Sequoyah Nuclear Plant, Units 1 and 2
Facility Operating License Nos. DPR-77 and DPR-79
NRC Docket Nos. 50-327 and 50-328

Watts Bar Nuclear Plant, Unit 1
Facility Operating License No. NPF-90
NRC Docket No. 50-390

Subject: **Insights from Questions and Responses From March 25, 2010
Discussion Regarding Generic Letter 2004-02, Potential Impact of
Debris Blockage on Emergency Recirculation During Design Basis
Accidents at Pressurized Water Reactors**

Insights from Questions and Responses from March 25, 2010 Discussion Regarding GL 2004-02 Strainer Testing

Test Apparatus Layout

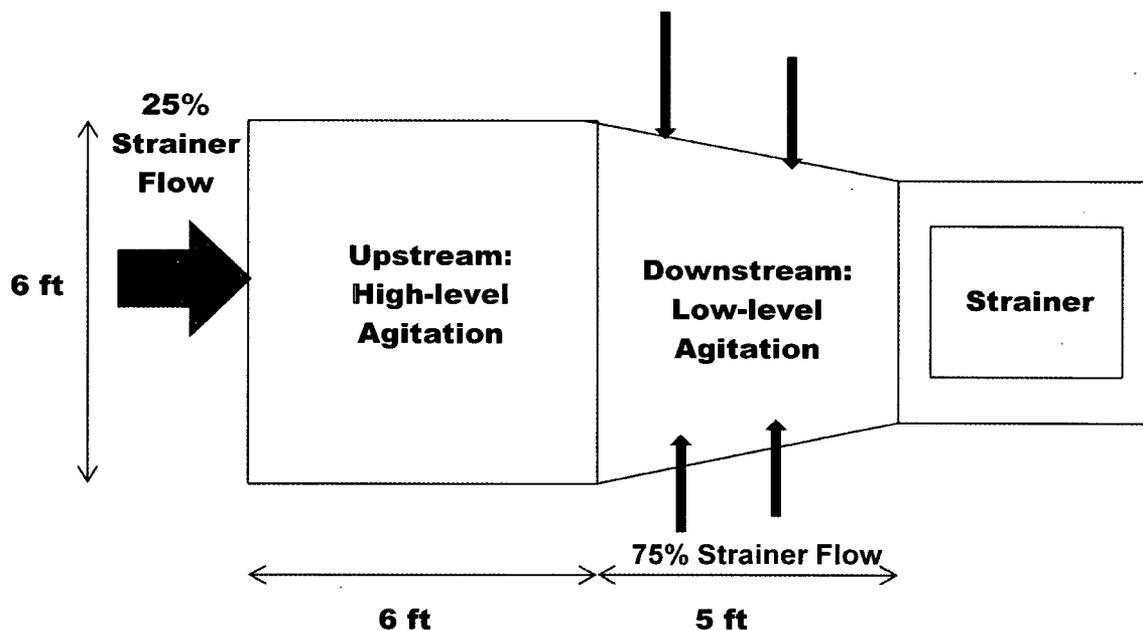
1. Test Strainer's Configuration – The staff agrees we can / should confine the test strainer on 3 sides; leaving one face on the upstream side of flow to the strainer fully exposed. The distance between the walls and test strainer shall be one half the gap distance between strainers in an array. See test configuration concept below.
